### **ADDENDUM #3**

#### **Rye City School District**

***Issued: 2021-02-11***

**This Addendum No. 3 forms part of the Contract Documents and modifies the original bidding documents dated, January 19, 2021.**

SEAL & SIGNATURE DATE: 2/11/2021  
PROJECT No: 9200  
DRAWING BJMM/MDDB  
CHK BY: MJM  
DWG No: AVE2-111

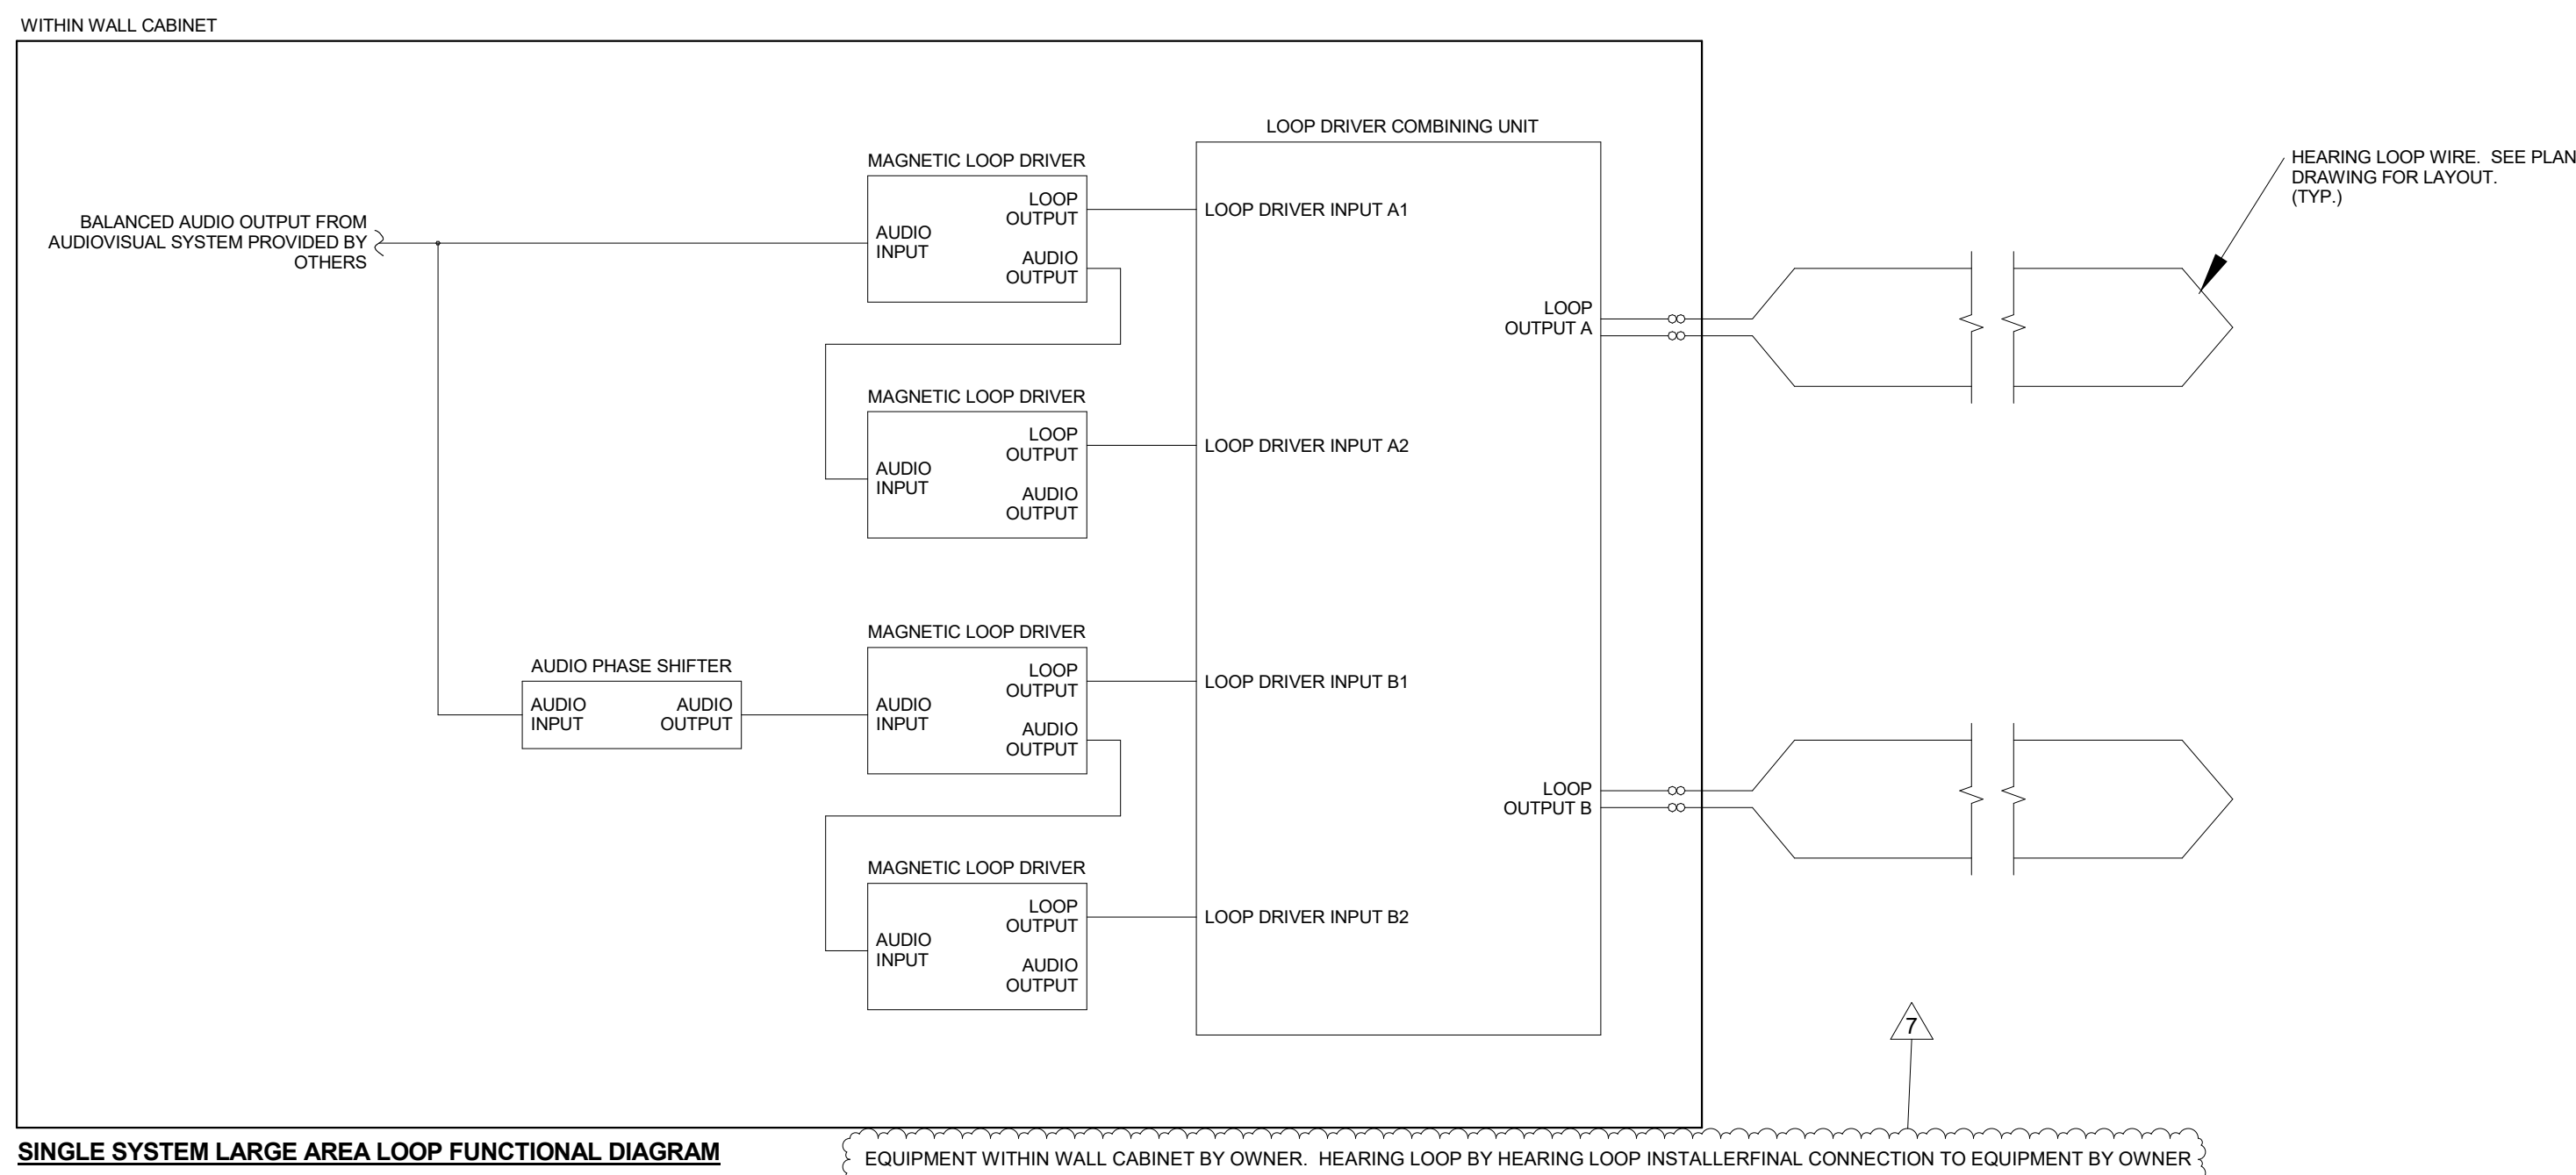
19. AVE2-111
  - a. Notes have been added to these drawings to clarify the scope of work between EC and Owner's AV vendor.
20. AVE2-112
  - a. Notes have been added to these drawings to clarify the scope of work between EC and Owner's AV vendor.

6 **HS Entry Transaction Counter Detail**  
SCALE: 1" = 1'-0"

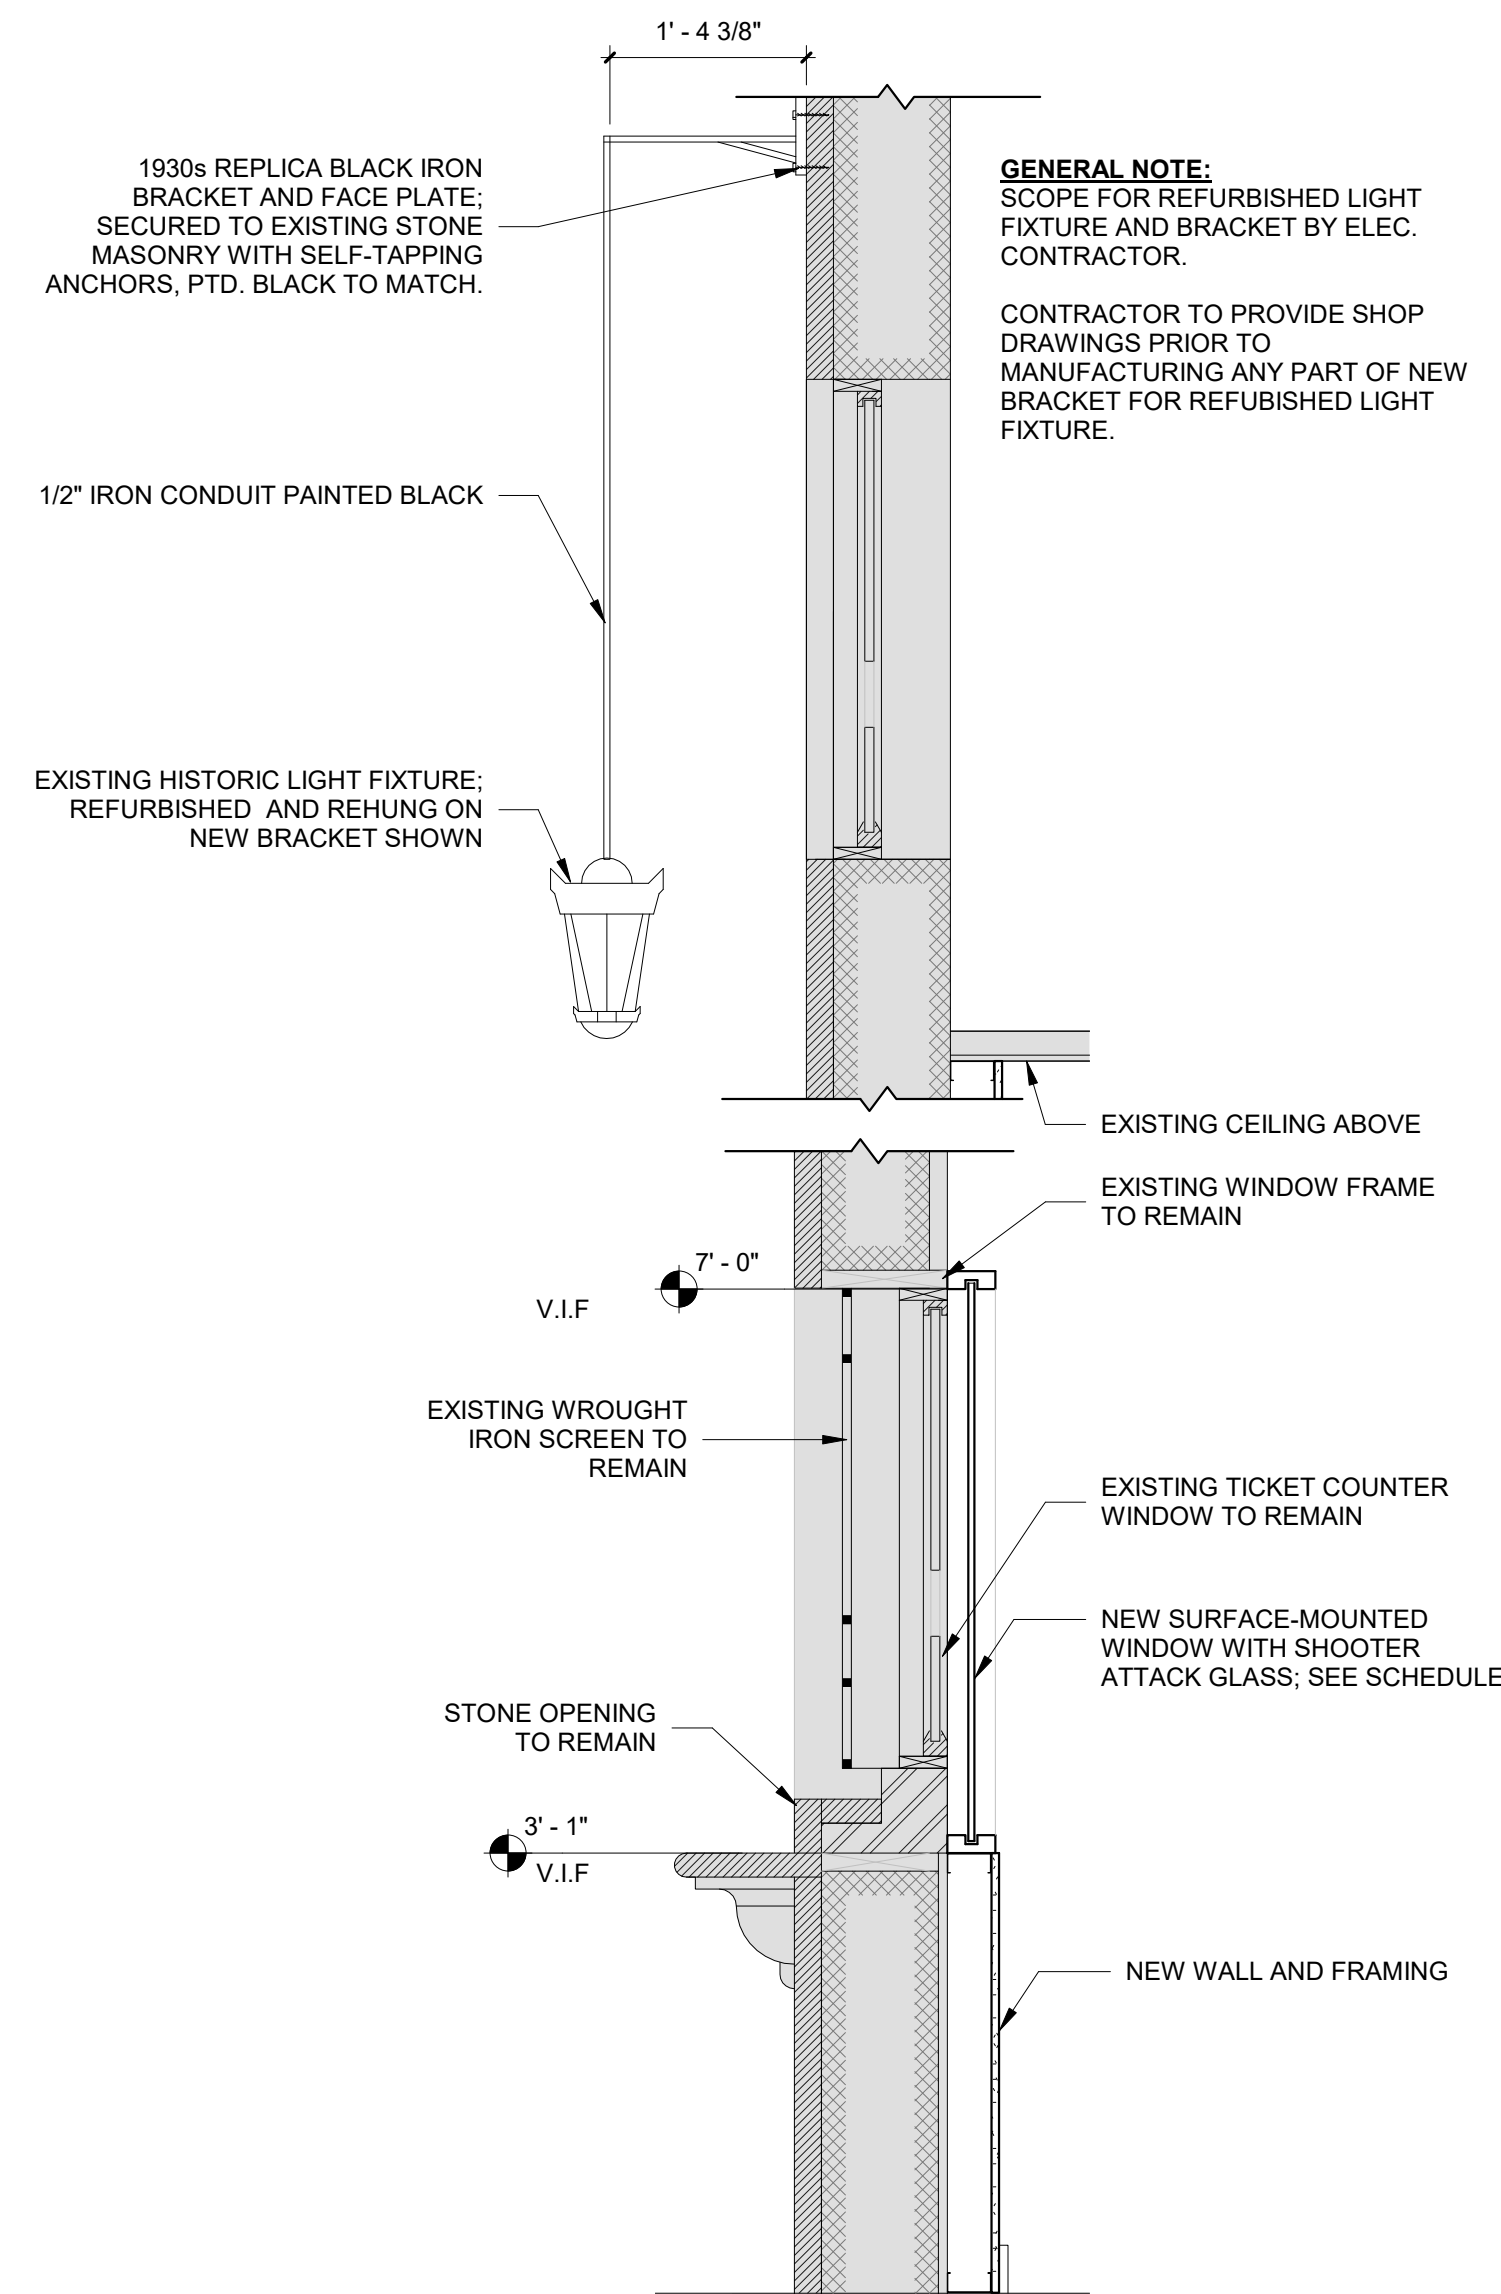
- a. Plan detail of HS Entry transaction counter added; Detail 1/A2-321 updated to remove built-in security desk.
